**RE: Harper Senior Living
Grading and Drainage Plan
Engineer's Stamp Date: 11/16/18
Hydrology File: E20D020B**

Based upon the information provided in your submittal received 11/16/2018, the Conceptual Grading Plan and Drainage Report **is not** approved for action by the DRB for Site Plan for Building Permit. The following comments need to be addressed for approval of the above referenced project:

C-100

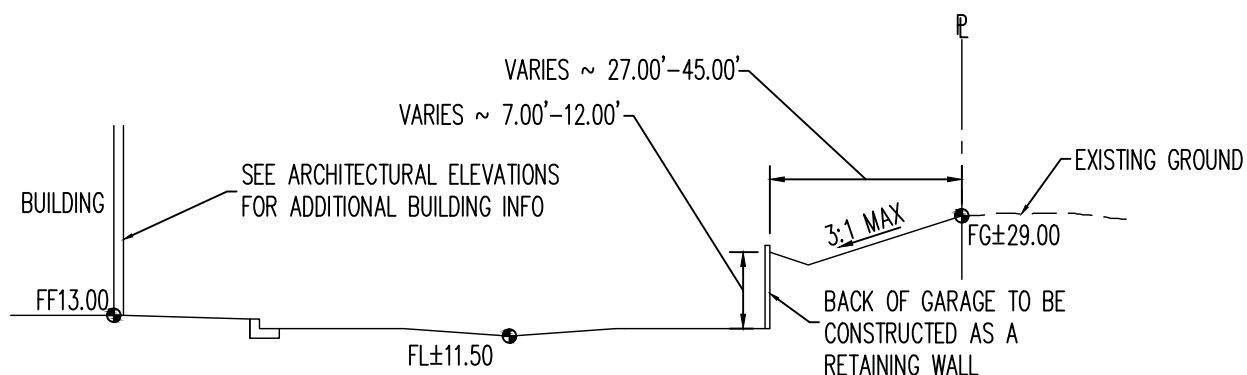
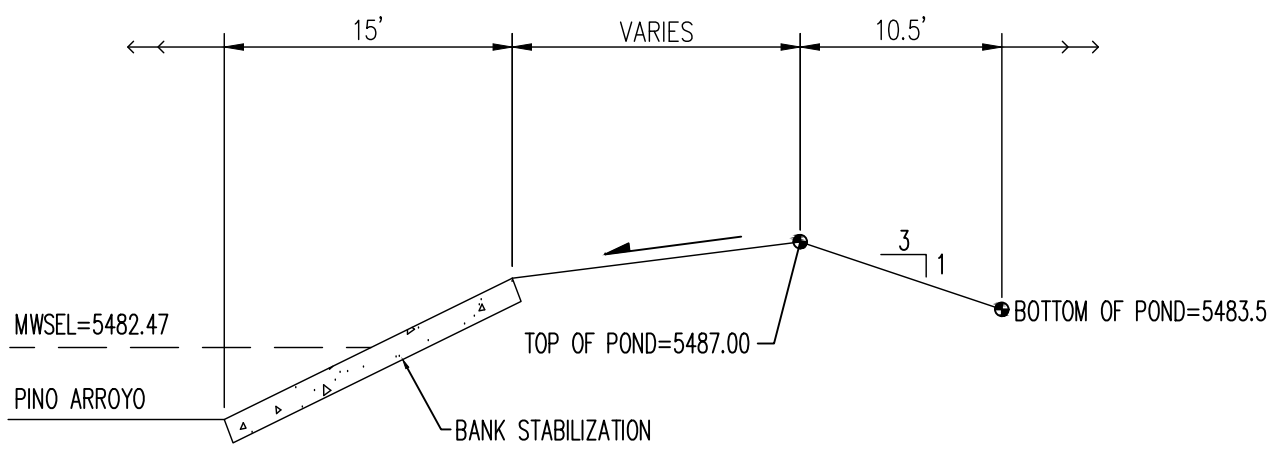
1. Sheet C-100. Please provide the FIRM Map and flood plain note with effective date.
2. Sheet C-100. Please provide a vicinity map showing the location of the site.

3. Sheet C-100. Please provide the legal description of the property.
4. Sheet C-100. Please provide the benchmark information for the survey contour information provided.

5. Sheet C-100. Please label the 100 year flood elevation line. Also please make this a bolder and different line type to differentiate this with the contour lines.

6. All sheets. Please enlarge the existing index contour line text. This text should be at least 0.10 inches high.
7. Sheet C-100. Near the west driveway and on the south side of the sidewalk, the proposed contours are too steep; please provide a retaining wall along this section of the sidewalk.

8. Sheet C-100. Please relocate the outfall pipe for Pond 2 to the east away from the City's drainage ditch's flow line. Also please provide a headwall at the outfall and provide energy dissipation.

9. Sheet C-100. Please wrap the bank protection around and into the City's drainage ditch past the pond. This will stop any erosion.
10. Sheet C-100. Please concrete line the bottom and sides of Pond 1 per AMAFCA's instructions to prevent the bank protection from erosion.
11. Sheet C-100. Please relocate the outfall pipe for Pond 1 to the east away from the City's drainage ditch's flow line. Also this outfall pipe will be thru the bank protection and provide energy dissipation in the South Pino.
12. Sheet C-100. It appears that half of proposed Basin 1 will not find its way into Pond 1 and instead discharge directly into the South Pino Arroyo via AMAFCA's maintenance drive. Please correct grading to insure that the drainage goes to Pond 1 and not down this maintenance drive.
13. Sheet C-100. Please correct Section B to match the bank protection section that was in the CLOMR.

C-001

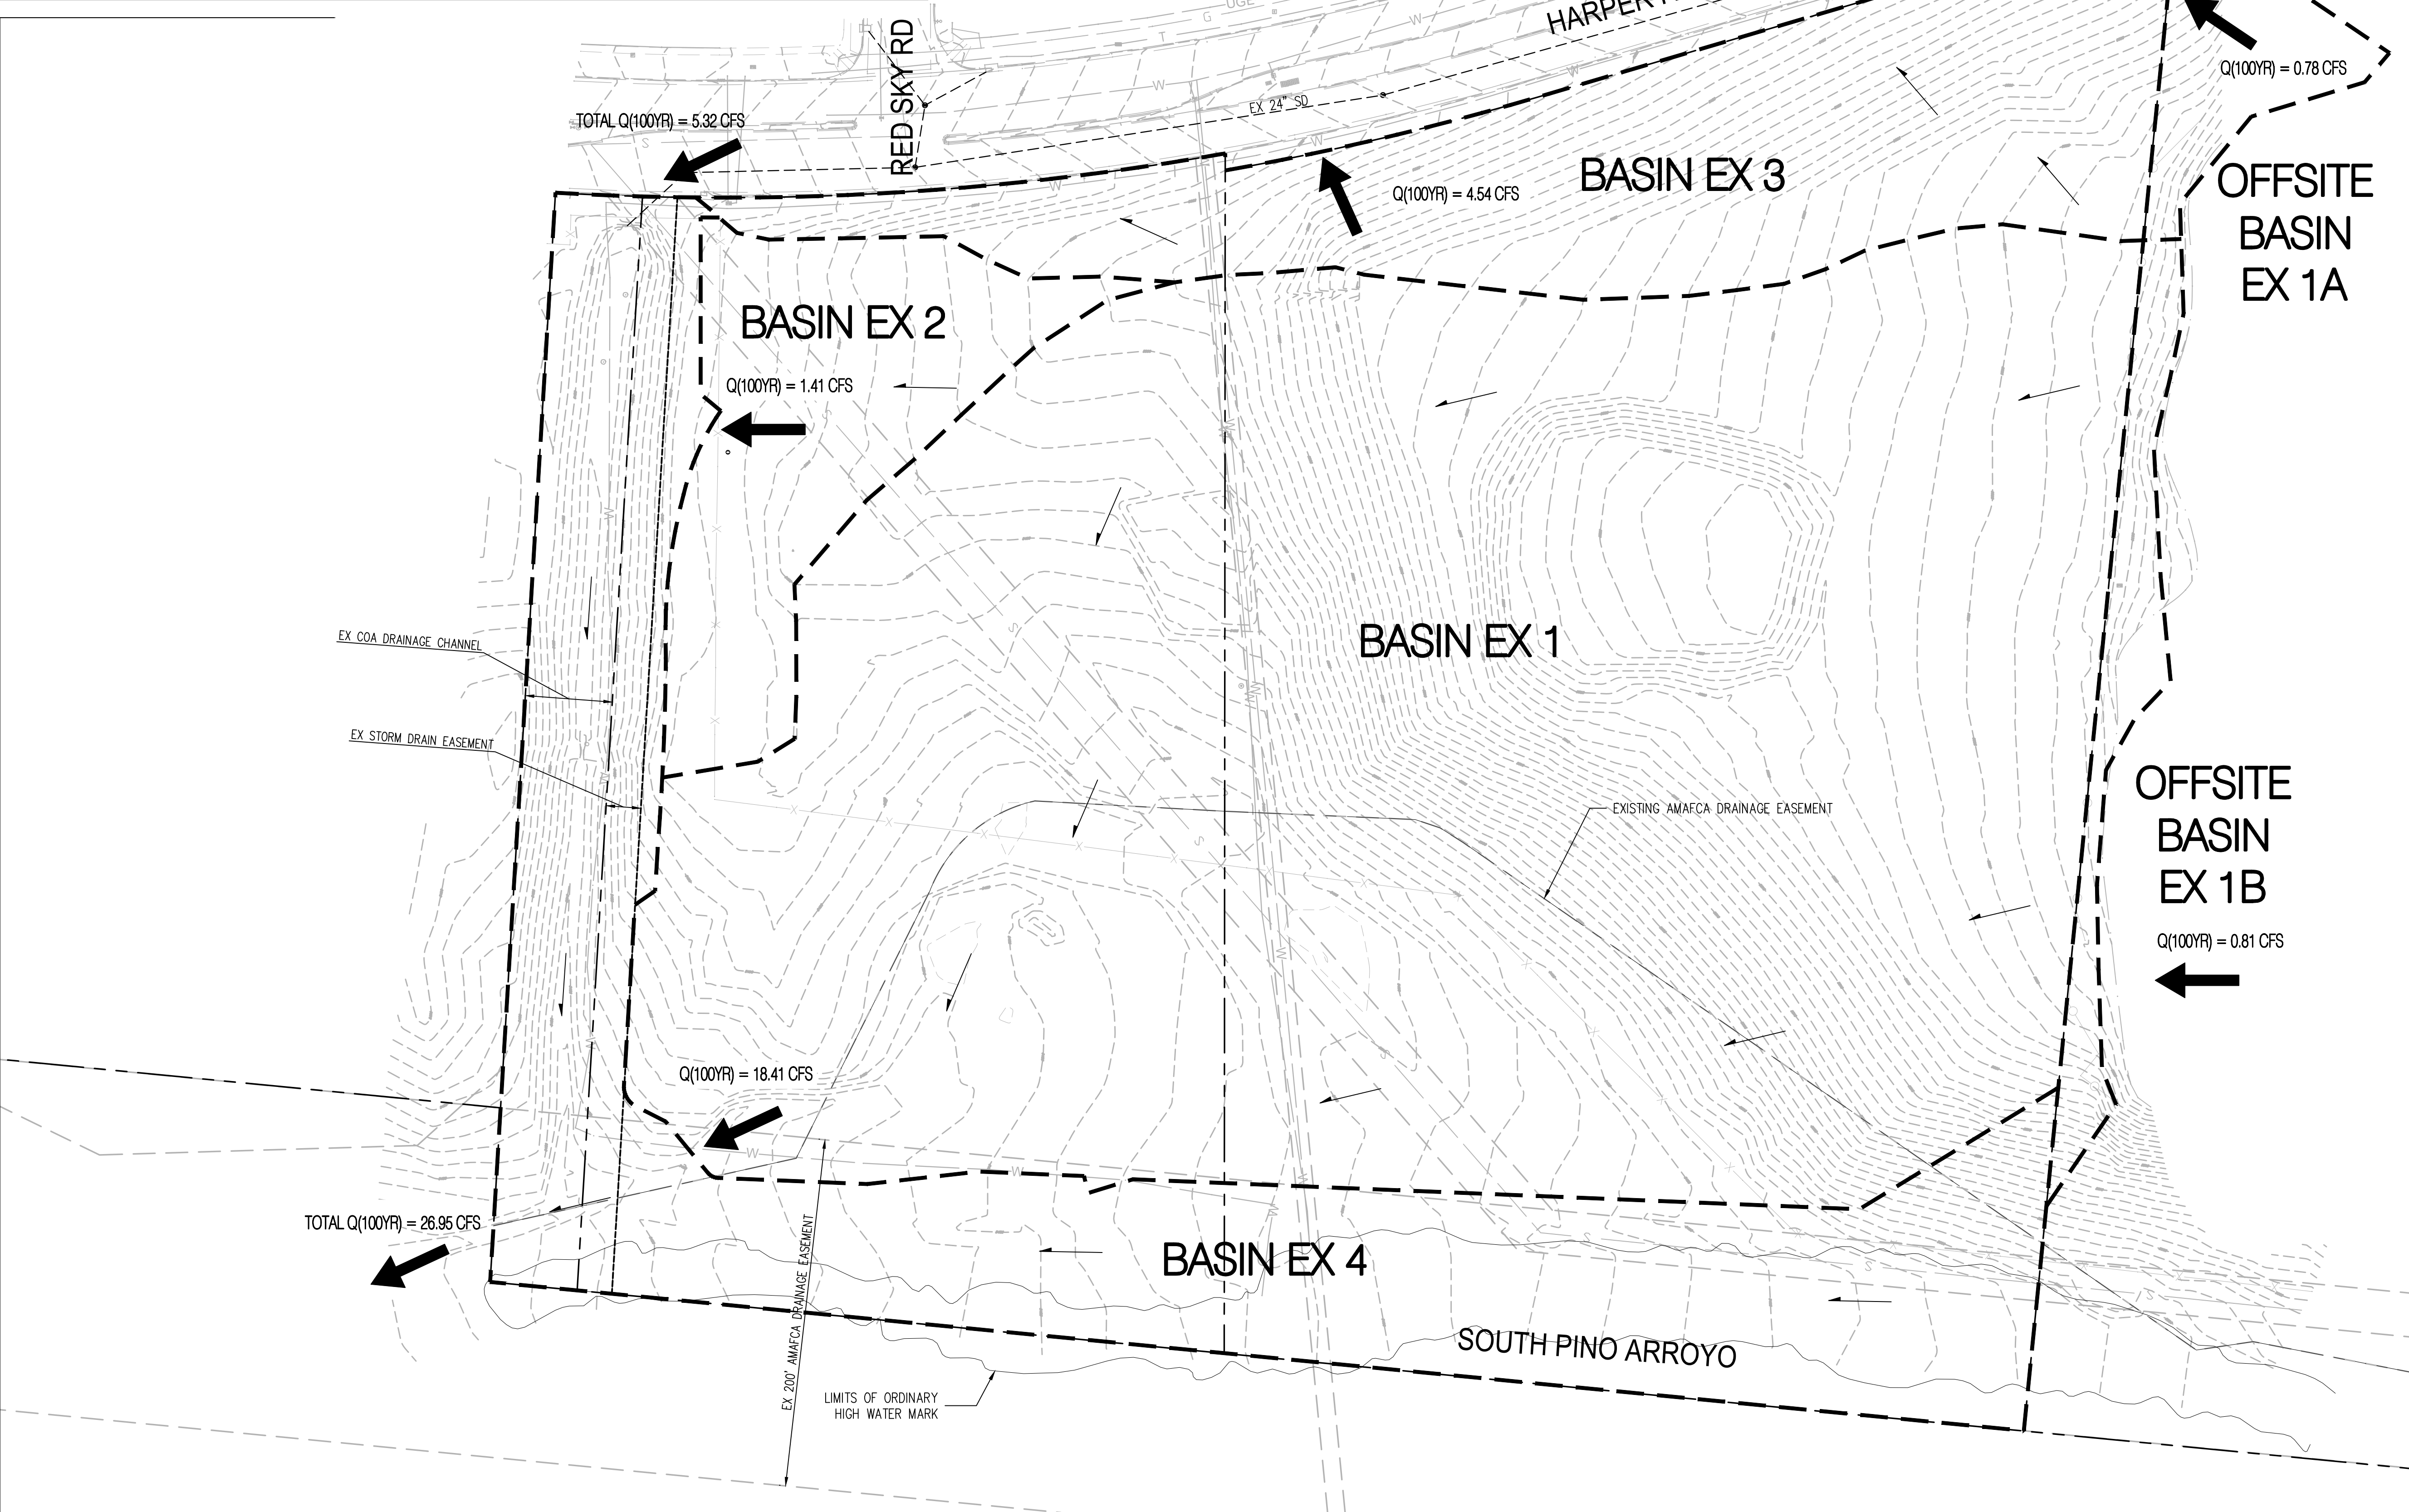
14. Sheet C-001 & C-002. Please verify the off-site drainage basins. When reviewing the approved plans and aerial of the adjacent church, it appears that the drainage basins could be reduced and/or the drainage basin discharges directly to Harper Road instead of onto this site. Also please make the off-site drainage basins the same on both Sheets.
